# **SERVICE BULLETIN**

## **REICHHARDT RGS RECEIVER**

### **WAAS SATELLITE UPDATES**

*Reconfiguration of the preferred WAAS PRN for  
Reichhardt USA distributed receivers  
Effective May 2022*

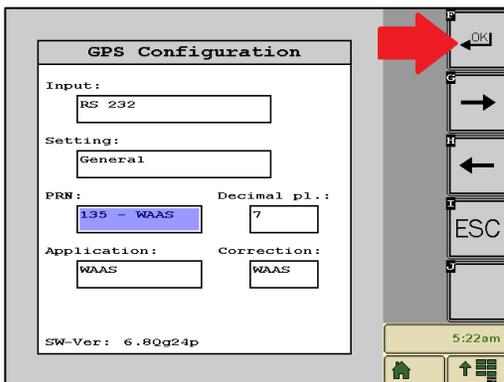
From the general receiver settings page, select the “PRN” dropdown list and select “135 – WAAS”.

**Note:** some of the other menu options on this page may vary based on receiver model and PSR software version. The only setting which needs to be changed is the PRN.

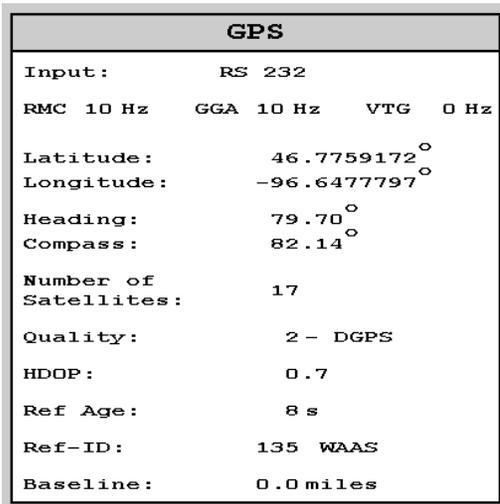
To verify the saved changes, from the main menu, select diagnostics (E), then press the right arrow soft-key until you are on the “GPS” page.

On this page, confirm:

Correction quality (should be “2 – DGPS”)  
 Ref-ID (should be 135 WAAS).

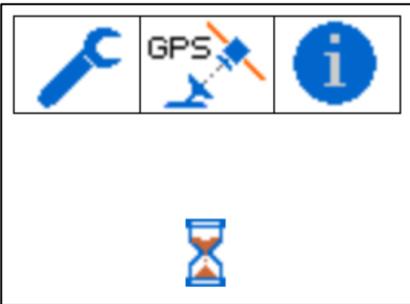
Use the down arrow soft-key to highlight “PRN 1”, then tap the “ok” repeatedly to change this value until it is set to “135”. Repeat this for “PRN 2”.

Press and hold the “OK” soft key to enter the save screen. Press “OK” again to save.
